Subject: Citrus County Central Class I Landfill Phase 3 Expansion
Certification of Construction - Request for Additional Information No. 1
Permit No.: 21375-013-SC/01,
Citrus County WACS No.: SWD/09/39859

On behalf of the Citrus County Solid Waste Division, SCS Engineers (SCS) submits the following responses to your request for additional information in a letter dated May 12, 2011. For ease of review, each Florida Department of Environmental Protection (FDEP) comments are reiterated in bold type, followed by our response.

CENTRAL LANDFILL PHASE 3 EXPANSION PROJECT CONSTRUCTION RECORD DRAWINGS

Date: 05/12/2011
Distance: 150.3 Ft
Obs: Debris (Not grease or silt)

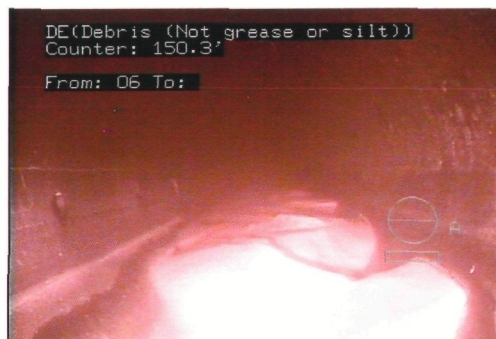
2. **Attachment 12-3 – Video Inspection Tape and Report:** As indicated in the video inspection report and confirmed by the Department's review of the video provided, the inspection camera was submerged under liquid for those portions of the leachate collection, sump, and cleanout pipes that were not located on the side slopes of Phase 3. The lack of restriction in movement of the camera in the pipe does appear to be an indication that the pipes were not obstructed. However, in the sections of the pipes where the camera was submerged and vision obscured, it does not appear that the absence of potential construct defects (e.g. pipe crushing, pipe separation, pipe buckling, etc) can be confirmed. Please either conduct a video re-inspection of leachate system, with liquids removed from the system to allow the constructed pipe to be seen and its integrity confirmed, or provide alternate supporting information that the permittee relied upon to verify the integrity of the constructed leachate system piping.

Response: A video re-inspection was conducted on May 12, 2011 showing that the pipe is defect free. Please refer to Attachment B for the revised report and footage in DVD format.

The explosion-proof video-inspection of the Leachate Collection Lateral 1 after it was dewatered show that the pipe is defect free. There is a 37.4' long segment of this pipe beginning at the 150.3' mark downstream of the East cleanout, and continuing to the 187.7' mark downstream of the East cleanout, that has approximately 1" deep new sand that was not present during the initial inspection conducted after construction in January 2011. This sand did not stop the camera from passing through this area, and would not affect leachate flow through this area, but can be flushed from the pipe if required.
